**PURPOSE:** Culvert removal and beach restoration  
**DATUM:** MLLW (MHHW = +8.4' MLLW)  
**ADJACENT PROPERTY OWNERS:**  
 Burton Baxter                      Heinrich Family Trust  
 Patrick & Mary Frost            Stephen & Marnie Hofeditz  
 Kevin Engels                        John Goodman

**CHUCKANUT VILLAGE MARSH**  
**Parking Area**  
 1"=30'  
**OWNER AND ADDRESS**  
 City of Bellingham  
 210 Lottie Street  
 Bellingham, WA 98225

**PROPOSED:** Culvert removal and beach restoration  
**IN:** Chuckanut Bay  
**COUNTY:** Whatcom      **STATE:** WA  
**APPLICATION BY:** City of Bellingham

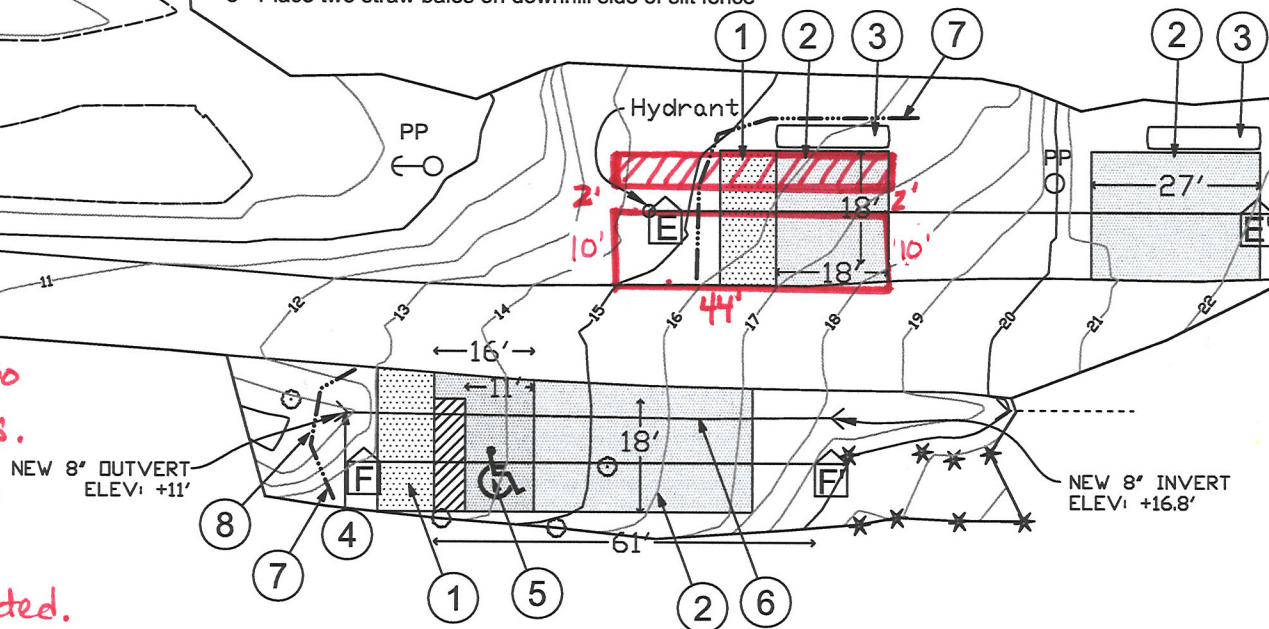
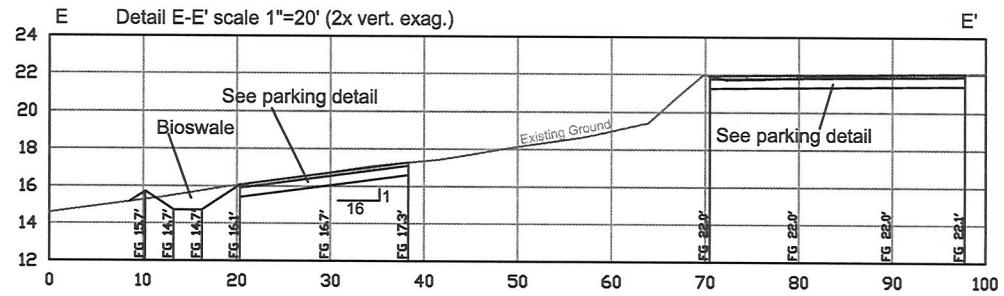
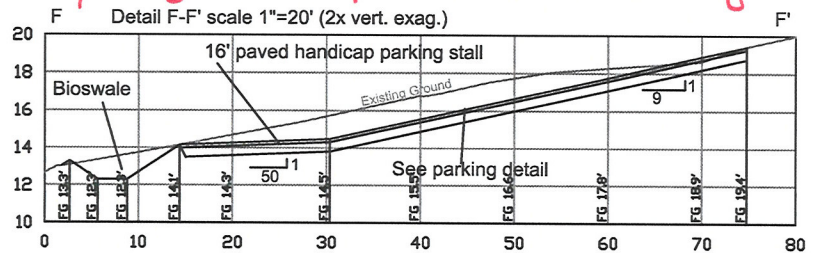
*Approx. location of two parallel parking spaces. Each space is approx. 22 ft by 8 ft.*

*Hydrant to be relocated. Privacy hedge to be expanded to 44 ft. Long.*

*Revisions not to Scale.*
